Access Compliance Report

Public Rights-of-Way

(Curb Ramps)

Intersection ID: N/A	Main Street: CLEMS_BRANCH_DR	Cross Street: N/A	Location: W
ADA ID: B6B8982953D1	Ramp Type: Perp	Initial Pass/Fail: Fail	Overall Compliance: No
		Severity Score: 10

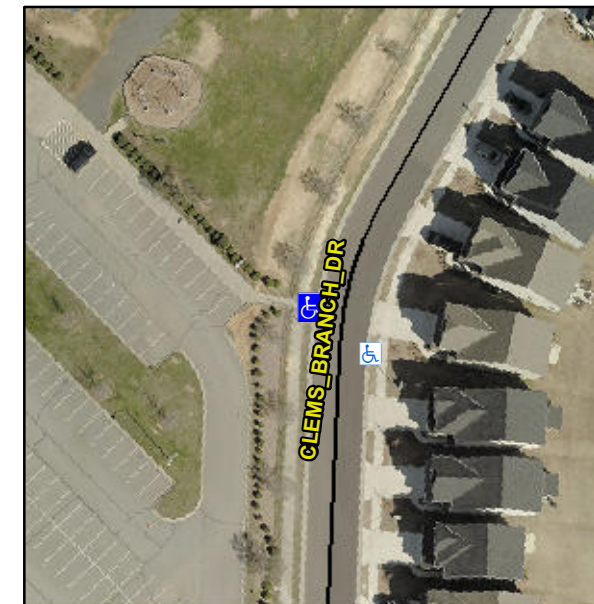
Not Found, R304.5.1, R304.5.3

Compliance	Description	Data	Compliance	Description	Data
N/A	Ramp Length (in)	69.0	Yes	Ramp Slope (%)	6.9
No	Ramp Width (in)	47.0	No	Ramp XSlope (%)	3.4
N/A	Flare Type LT	N/A	N/A	Flare Type RT	N/A
N/A	Flare Slope LT (%)	N/A	N/A	Flare Slope RT (%)	N/A
N/A	Flare Traversable LT?	N/A	N/A	Flare Traversable RT?	N/A
N/A	Landing Length (in)	N/A	N/A	DWS Provided?	N/A
N/A	Landing Width (in)	N/A	N/A	DWS Contrast?	N/A
N/A	Landing Slope (%)	N/A	N/A	DWS Length (in)	N/A
N/A	Landing X Slope (%)	N/A	N/A	DWS Full Width?	N/A
N/A	Landing Curb? (Y/N)	N/A	N/A	DWS Offset (in)	N/A
N/A	Shared Landing?	N/A			
N/A	Gutter Ponding?	N/A	N/A	Gutter Slope (%)	N/A
N/A	Gutter Lip Ht (in)	N/A	N/A	Gutter X Slope (%)	N/A
N/A	Painted X Walk1?	No	N/A	Painted X Walk2?	N/A
	X Walk 1 Direction	To SE		X Walk 2 Direction	N/A
N/A	X Walk 1 Width (in)	N/A	N/A	X Walk 2 Width (in)	N/A
	X Walk 1 Slope (%)	3.5		X Walk 2 Slope (%)	N/A
	X Walk 1 X Slope (%)	1.9		X Walk 2 X Slope (%)	N/A

Remove & Replace Entire Ramp.
